SERVICE LETTER 00112 R1

Subject: RV-12iS Optional Cooler Replacement

Affected Models: RV-12iS

Required Action: Replace Oil Cooler and Radiator

FIGURE 1: Radiator and Oil Cooler Assembly

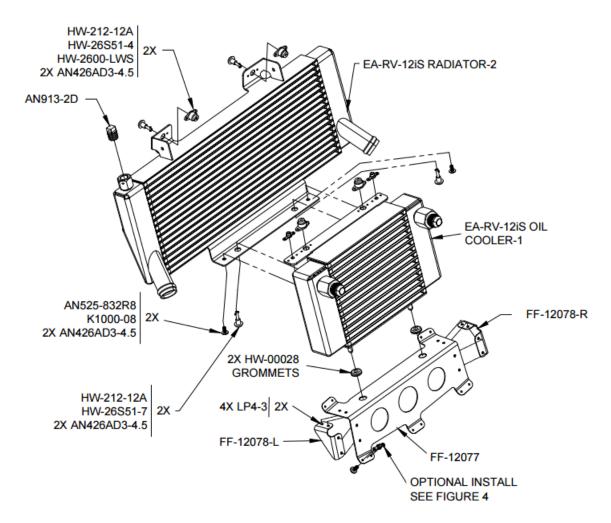
<u>Step 2:</u> Machine countersink and rivet K1000-08 and HW-212-12A camlock receptacles to EA-RV-12iS OIL COOLER-1 and EA-RV-12iS RADIATOR-2 as shown in Figure 1.

<u>Step 3:</u> Bolt Oil Cooler and Radiator together using two AN525-832R8 bolts to create Oil Cooler and Radiator Assembly, Figure 1.

Step 4: Install 2x HW-00028 grommets into FF-12077, Figure 1.

Step 5: Install FF-12078-L & -R into FF-12077 using LP4-3 Rivets, Figure 1.

FIGURE 2: Assembled Radiator and Oil Cooler

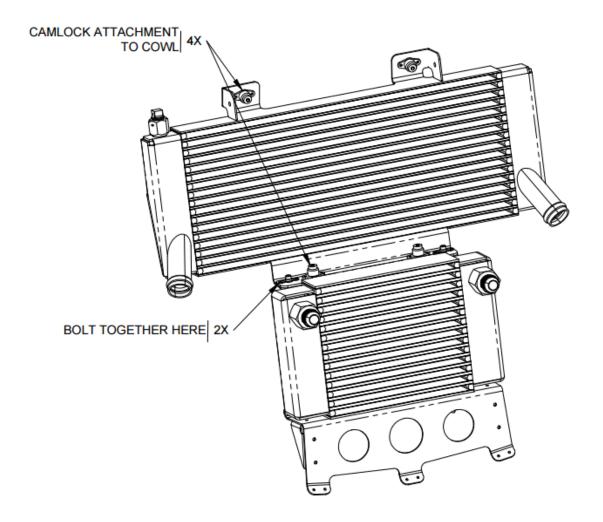
<u>Step 6:</u> Slide FF-12077 onto Oil Cooler pins through grommets until bracket rests against the bottom of Oil Cooler. Final assembly as shown in Figure 2.

FIGURE 3: Radiator & Cooler Installed in Cowl

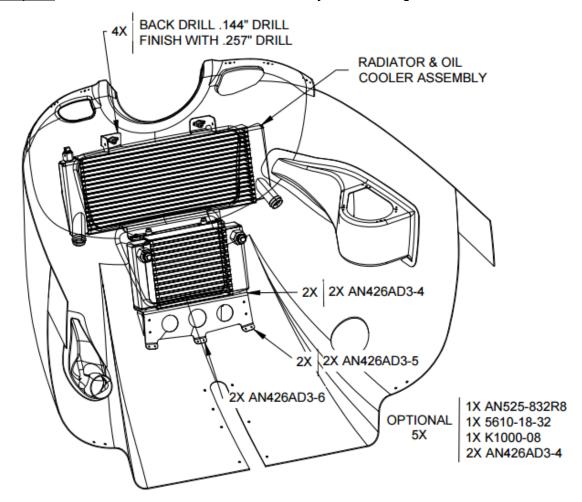
Step 10: Place the Radiator and Oil Cooler assembly in the cowling as shown in Figure 3. Align center marks to locate Radiator and Oil Cooler left/right. Face of bracket should sit on cowl as shown in Figure 3. Face of the Radiator and Oil Cooler should sit centered in respective cowl openings up/down. If nutplates are installed for winterization kit, the two interfering with this installation must be removed before proceeding.

<u>Step 13:</u> Final drill camlock locations to using #F (0.257 in.) drill bit through cowl (x4), Figure 3.

<u>Step 15:</u> Match-Drill #40 (.098 in.) and machine countersink holes for FF-12077 into cowl. Rivet lower bracket to cowl using hardware as shown in Figure 3. The radiator and cooler assembly is now attached to the cowl.

FIGURE 4: Optional Nutplate installation into FF-12077

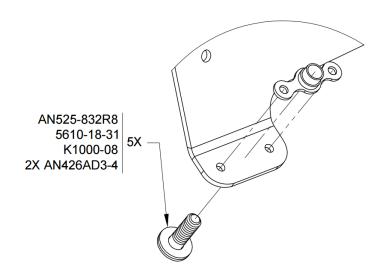
NOTE: If rivet gun is not available for installing AN426 rivets through cowl, lower bracket can instead be installed on cowl by installing K1000-08 nutplates directly into FF-12077. FF-12077 is then installed into cowl by back-drilling #19 holes through cowl and securing with AN525-832R8 & Washer 5610-18-32. See Figure 4.

FIGURE 5: Attach Radiator and Cooler to the Engine with FF-12081

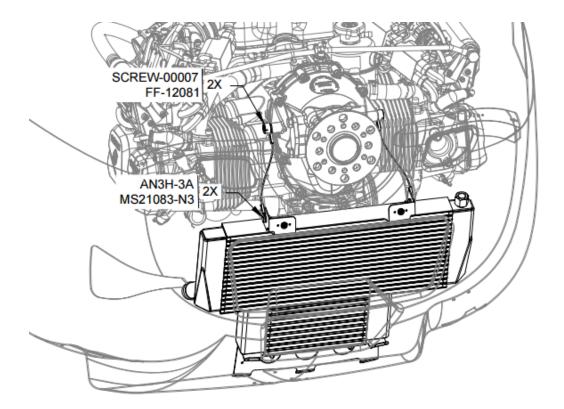
Step 16: Install 2X FF-12081 to radiator using 2X AN3H-3A and 2X MS21083-N3 as shown in Figure 5. Protect fins on inside face of radiator with a piece of cardboard during installation. The protective piece can be removed once all tubes and hoses are installed.

<u>Step 17:</u> Temporarily install lower cowl (with coolers and radiator) onto aircraft. Install 2x FF-12081 to engine as shown in Figure 5 using 2x SCREW-00007. Torque to 190 in-lb and safety wire.

FIGURE 6: Radiator and Oil Cooler Tube and Hose Install – Right Side

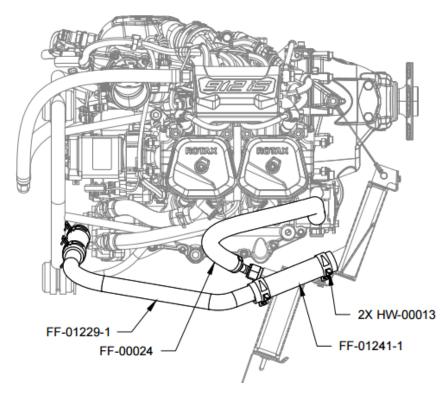
<u>Step 20:</u> Attach FF-01229-1 Radiator Tube Output and FF-01228-1 Radiator Tube Input to the radiator as shown in Figure 6 & 7 using new FF-01241 and HW-00013.

<u>Step 21:</u> Attach FF-00023 and FF-00024 to EA-RV-12iS OIL COOLER-1 per Figure 6 & 7. Torque AN8 fittings to 270 in-lb. using a backing wrench on integrated fitting.

FIGURE 8: Heat Shield Clearance

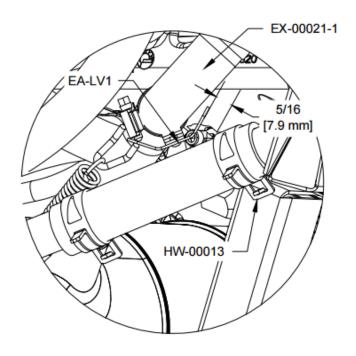
<u>Step 23:</u> Check the clearance between EA LV-1 Heat Shield installed on EX-00021-1 Cylinder #1 Exhaust and the forward HW-00013 installed on FF-01229-1. Adjust the clocking of EX-00021-1 as necessary to ensure a minimum 5/16 in. clearance while maintaining a minimum engagement of 1 in. inside both EX-00021-1 slip joints. See Figure 8.
